September 14, 2012

Re: Revised Plans and Response to DEQ letter of September 4, 2012
MDEQ File No. 11-52-0075-P; Proposed CR 595

Exhibit 3-55. Speed-Distance Curves for a Typical Heavy Truck of 120 kg/kW [200 lb/hp] for Deceleration on Upgrades

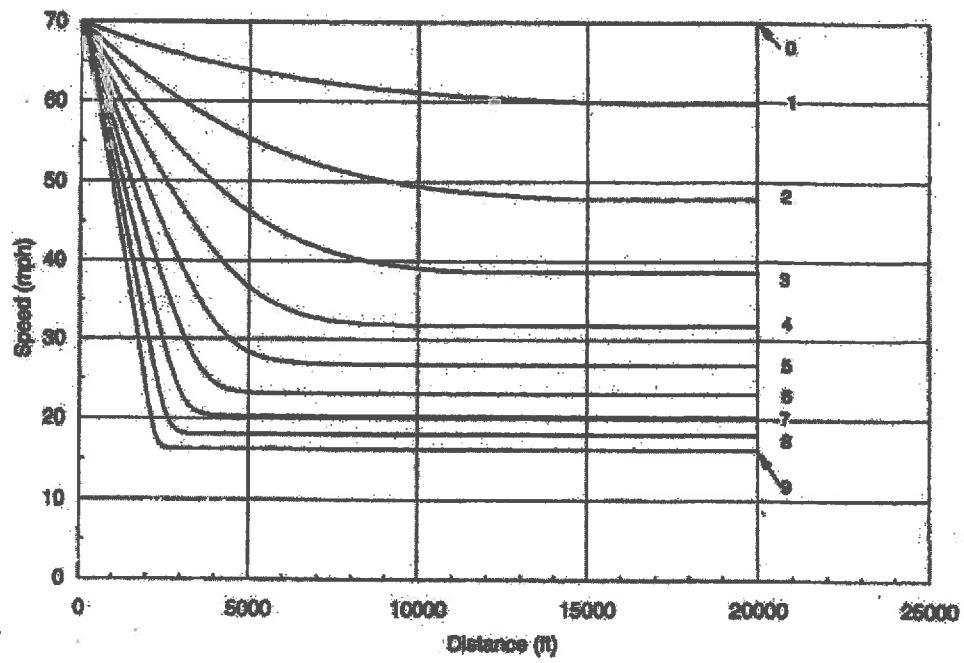
Also, please provide the reasoning for selection of the proposed passing lane locations and lengths. Please clarify whether a design with less and/or shorter passing lanes has been examined, and provide the corresponding documentation if it has been determined to not be feasible or prudent to reduce the length and/or number of proposed passing lanes. Also please clarify why passing lanes instead of truck climbing lanes are proposed, and describe the difference in these types of extra lane design, as applicable to the anticipated truck flow rate, anticipated traffic volume, and proposed road length.

Exhibit 3-55 from the AASHTO Greenbook displayed below illustrates the anticipated deceleration of a typical heavy truck on varying percentages of incline as indicated on the right side of the graph (0%-9%). In addition, Exhibit 3-57 displayed further below illustrates the anticipated deceleration of a typical recreational vehicle on varying degrees of incline. In the case of either trucks or recreational vehicles traversing the rolling terrain encountered along the proposed CR 595, those vehicles will unavoidably experience substantial deceleration on up-hill grades.
